Ref: WC-20844-OTH

23 July 2020

## **Re. Concession Variation Application – Opportunity to share your view - Griffin Creek Hydro Ltd concession**

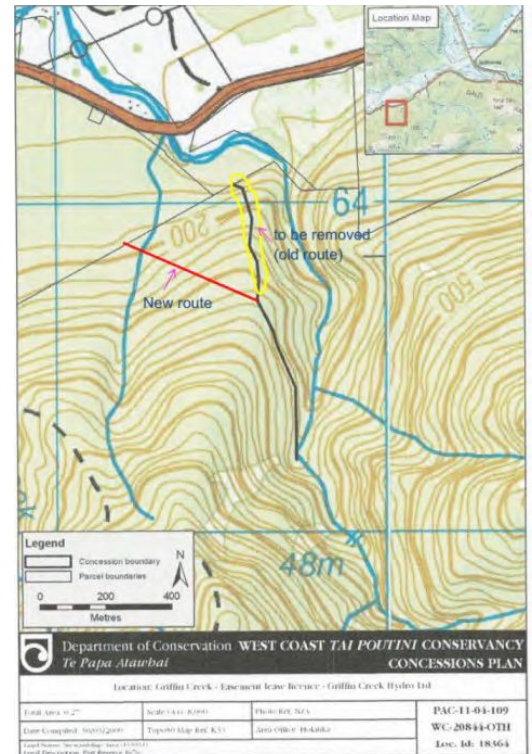
The granted scheme uses a 0.3m diameter penstock pipe laid around trees beneath the canopy. The varied scheme would entail the construction within a 6m wide corridor, with bedrock bluffs blasted and trees felled to bury a 1.2m pipe. This construction would create a significant amount of spoil, fallen trees and blasting debris which could fall down, creating a direct and unacceptable hazard to any person below. It would be unsafe for anyone to recreate in the lower gorge during construction, which means the applicant would need to have exclusive use of the land during that process, which is estimated at 2 years.

The proposed intake location is at a significant bend in the creek, which marks a transition between steep slopes and very steep slopes. (see in particular the terrain to the north of the '48m' label).

Although in theory it may be humanly possible, given the very steep slopes, it would be entirely impractical for canyoneers to try to exit the gorge upstream of the construction zone. This would mean that canyoneers would almost certainly avoid the upper canyon at any stage where it was unsafe or prohibited to continue below the proposed intake site location.
